Brighton Council

**MINUTES OF THE PLANNING AUTHORITY MEETING
OF THE BRIGHTON COUNCIL HELD
IN THE COUNCIL CHAMBERS, COUNCIL OFFICES, OLD BEACH
AT 5.30 P.M. ON TUESDAY, 2 JULY 2024**

6.1 Development Application DA 2024/0061 - Multiple Dwellings x 53 (51 new, 2 existing) at 24B & 38 Jetty Road, Old Beach

Figure 4: Building Envelope Diagram 1 showing envelope protrusion for units 23 and 24, and eaves excluded by 8.4.3 A3 from southern boundary (source: Application documents)

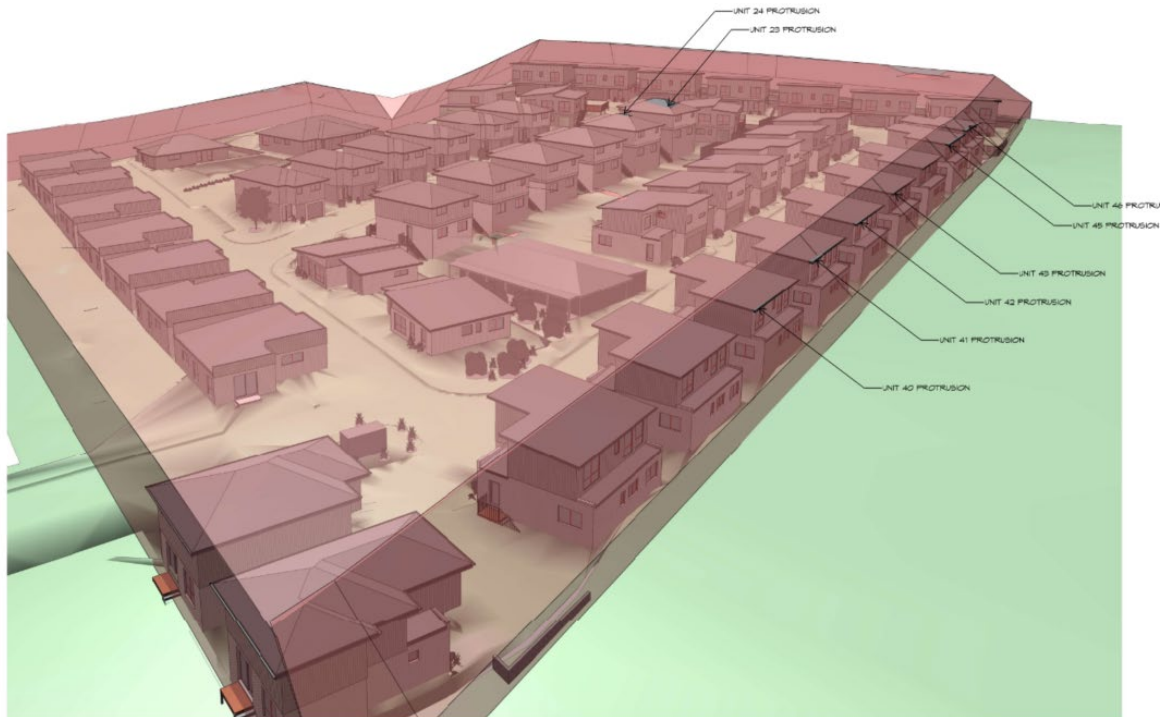
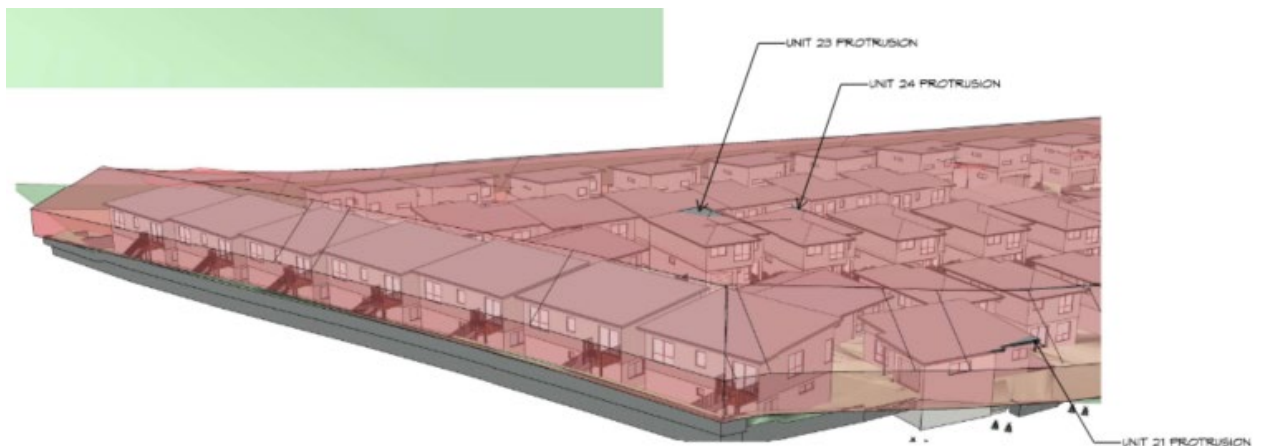
The proposal exceeds the building envelope for dwellings 21, 23 and 24, located in the centre of the site, whilst the protrusions for eaves along the southern boundary (being units 40 – 46) and northern boundary (unit 21) are excluded under 8.4.2 A3. The acceptable solution is not met, and assessment against the performance criteria is relied upon.

Figures 4 and 5 shows the Building Envelope Diagrams which form part of the proposal plans (sheet PD23405-09 Revision 05). The diagrams show the areas located outside of the building envelope.

The applicant has confirmed that it will reduce the height of units 21, 23 and 24, to ensure that all dwellings comply with the Acceptable Solution for building envelope required by 8.4.2. A3, and has requested that a condition be included in any permit requiring amended plans to be submitted to Council for approval, prior to commencement of any works or issue of any approvals required pursuant to the *Building Act 2016*.

- (a) the height of dwellings 21, 23 and 24 lowered to comply with the building envelope prescribed by 8.4.2 A3 of the Tasmanian Planning Scheme – Brighton.
